Technical Review Report for the Mound 1KW Package Safety Analysis Report for Packaging Waiver for the Use of Modified Primary Containment Vessel (PCV)

R1033-0064-ES-00

Docket 08-03-9516

LLNL-TR-405706

Figure 1. Fueled Capsule Assembly Payload [Showing the National Security PCV] (Figure 1.2.3-3 in Reference 2 of this TRR).

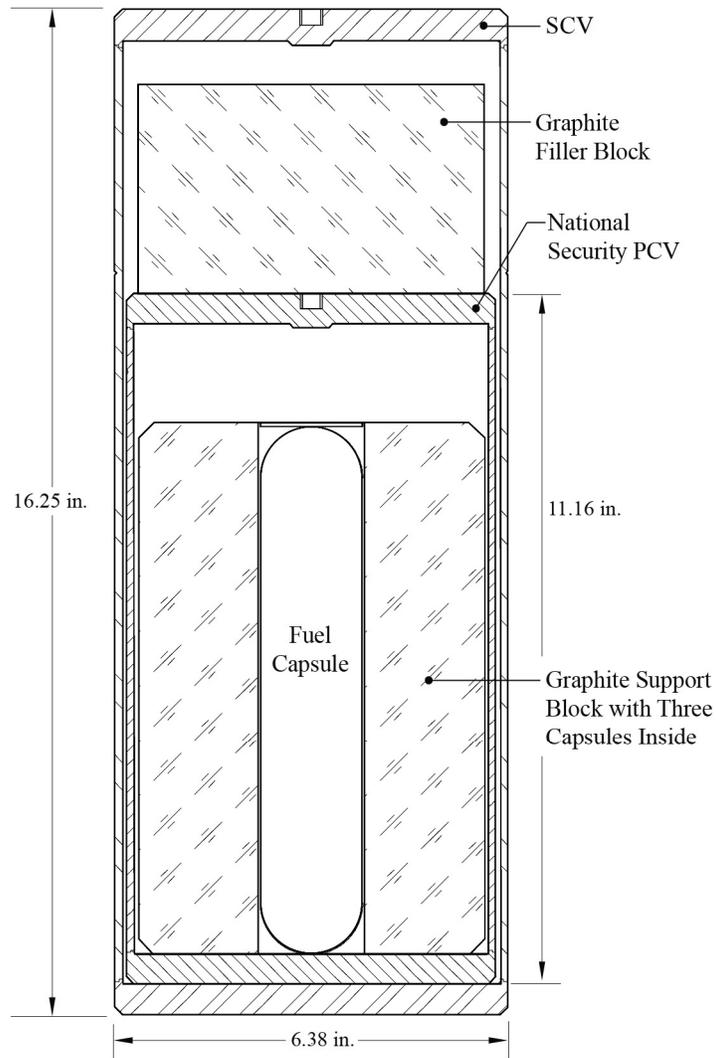
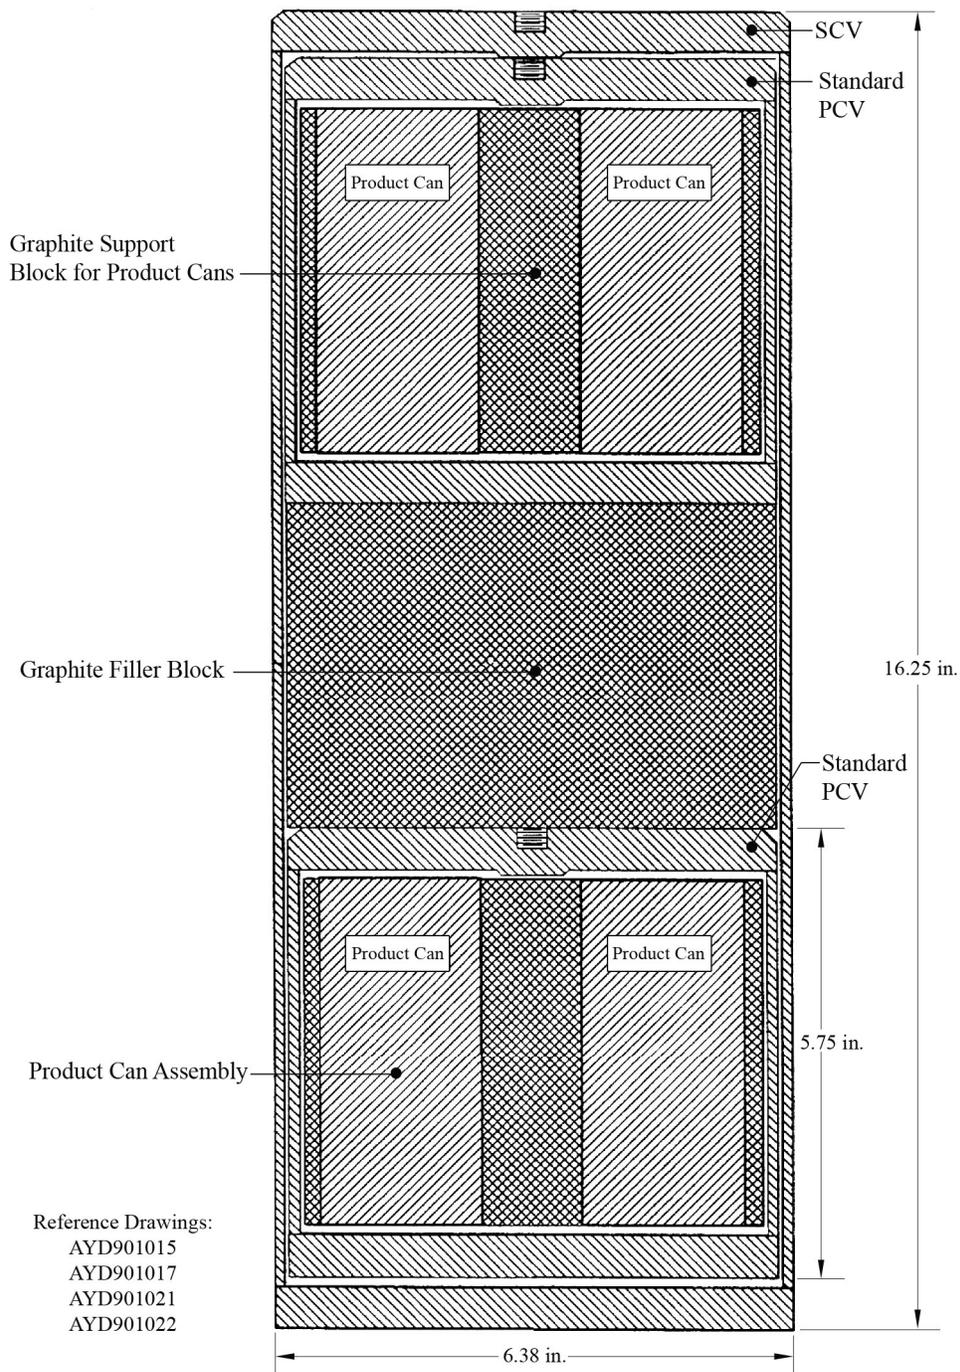
NE-34, Radioisotope Power Systems, Office of Nuclear Energy, proposes a modification of the existing national security PCVs (Drawing No. R1033-0069-ED-00) [Figure 1] to the specifications of the standard PCVs (Drawing No. R1033-0019-ED-01) [Figure 2] to meet the shipping requirements of NE-34. The standard PCVs and the national security PCVs are essentially identical in design except that the standard PCV is 5.75 inches in length and the national security PCV is 11.16 inches in length.

Steps to reconfigure the longer PCVs to the standard length PCVs would include machining the weld joint, machining a new cutting groove, and updating the laser etching on the can and lid. The existing weld, attaching the bottom lid to the body is not altered. The modification is to an approved design already accepted under the current SARP for the Model Mound 1KW Package. Drawings for the PCVs call for laser-marking the Drawing Number and Serial Number on the inside and outside of the body, in addition to laser marking the vessel lid. The parts will have to be laser-marked once again since the modified PCVs will now conform to a different Drawing Number and have different Serial Numbers.

A procedure must be written to describe the conversion of the national security PCVs, manufactured prior to December 31, 2006 per Drawing Number R1033-0069-ED-00, to the standard PCVs described in Drawing Number R1033-0019-ED-01. The staff has concluded that no additional operating procedure-related conditions of approval need to be added to the existing CoC^[4] for the approval of this request.
